## V2500-A1 SERIES PROPULSION SYSTEM SERVICE BULLETIN

This document transmits Revision 1 to Service Bulletin EV2500-72-0041 and the Initial Issue of the Supplement

# V2500-ENG-72-0041

ENGINE – HP COMPRESSOR – INTRODUCTION OF A NEW REAR ROTATING SEAL AND A NEW REAR  
STATIC AIR SEAL ASSEMBLY

Figure 1  
Location of HP compressor rear brush seal assembly

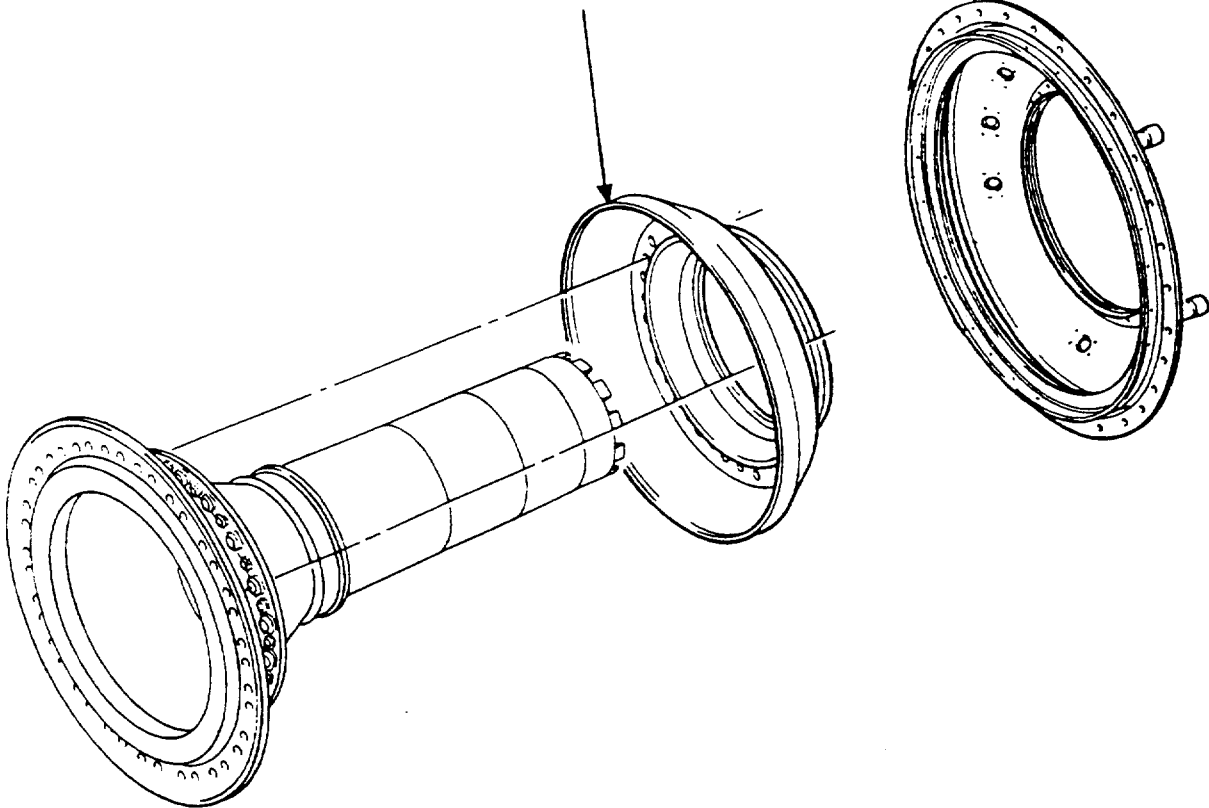
(a) The diameter of the brush seal has been reduced from 14.100in (358,14 mm) to 12.400in (313,96 mm)

(c) The static brush seal has been repositioned from sealing on the diameter of the shaft nine disc, to sealing on the diameter of the modified rotating disc.

REMOVE 6A3306 SEAL AND  
INSTALL 6A3932

REMOVE 6A3305 SEAL AND  
INSTALL 6A4113 SEAL

- R (1) Refer to Figure 1. New PN6A4113 HP compressor rear rotating seal and new  
R PN6A3932 HP compressor rear static air seal are only interchangeable as a  
complete set with in use rotating and static seals.
- (2) Assemble in accordance with approved procedures, Engine Manual, 72-41-00,  
Assembly.

Figure 2  
Install the Identification Plate

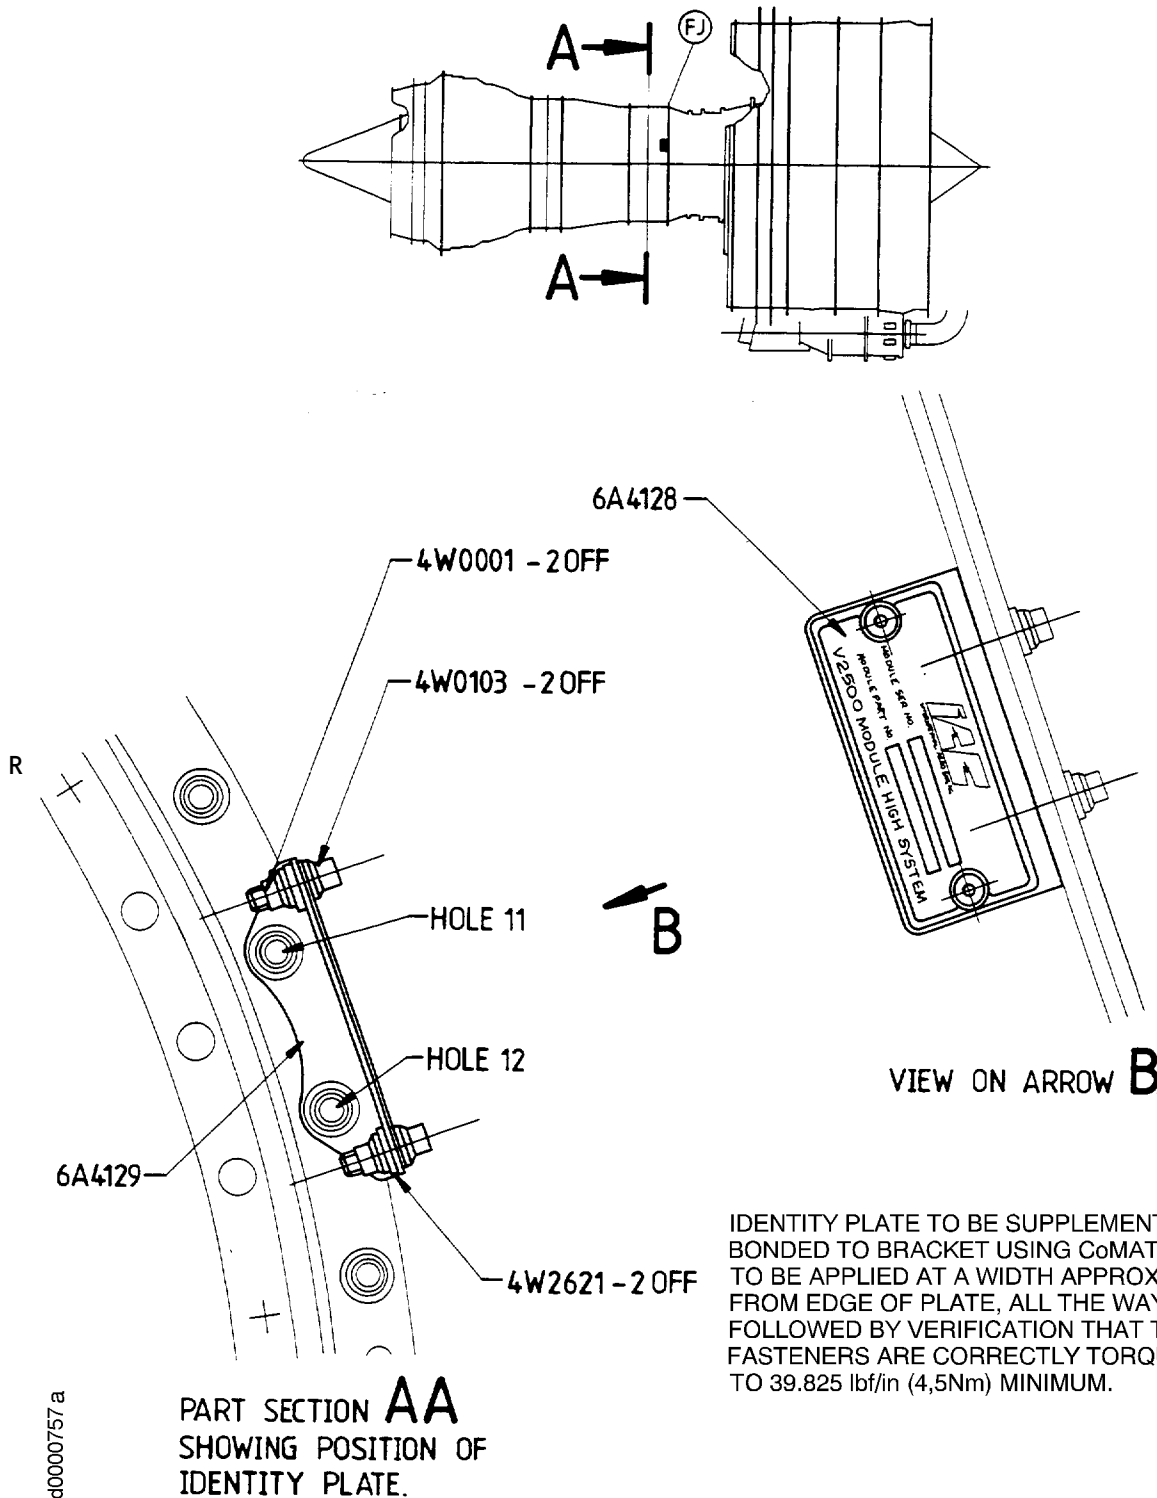
Reason for change  
To add installation  
procedures of the  
identification plate

- R (3) Prepare the new module  
R identification plate See Figure 2
- R (4) Remove the two bolts and existing  
R module identification plate from  
R the HP compressor front case.
- R (5) Make a mark of the new module part 4W6193 to 4W6407  
R number 4W6193 and the existing Refer to SPPM 70-09-00, marking of  
R serial number 4W6407 on to the new parts  
R plate.
- R (6) Install the new module  
R identification plate with the  
R existing two bolts to HP compressor  
R front case.
- R (7) Torque the bolts to 36 to 45 lbfin
